U.S. Department of Energy
Office of Civilian Radioactive Waste Management

Use of Risk Information to Address Key Technical Issue Agreements

NRC/DOE Technical Exchange and Management Meeting on Risk Information

Overview of NRC Perspective on Risk-informed Issue Resolution

Analysis of TPA 4.1J High Realizations

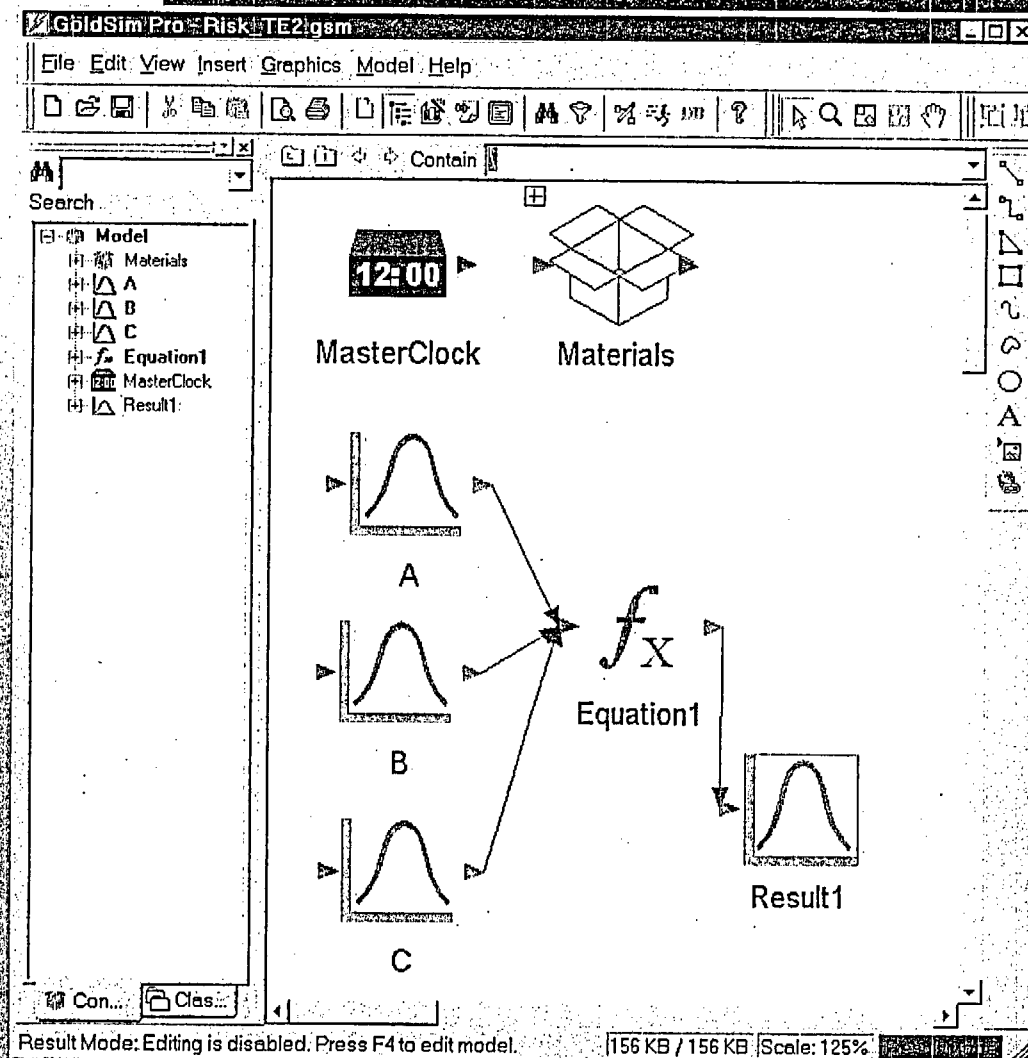
- The highest realization contributed 16% to the mean.
- It is not necessary for key parameters to be at the extremes in order to have a meaningful contribution to risk.
- Propagation of uncertainty significantly influences the risk.
